<u>Subject</u>: Transmittal of Revision 1 to Service Bulletin Number

V2500-ENG-73-0029

Transmittal Page 1 of 1 ENGINE - FUEL AND CONTROL - PROVIDE A NEW DATA ENTRY PLUG KIT ASSEMBLY AND FLANGE FC ATTACHING HARDWARE FOR THE ELECTRONIC ENGINE CONTROL (EEC)

V2500-A1

Family Tree - Data Entry Plug Assembly Figure 1

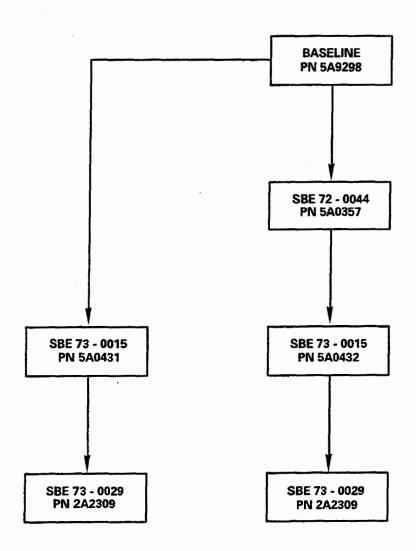
To change the compliance category, add marking information, correct the material information and correct the family tree.
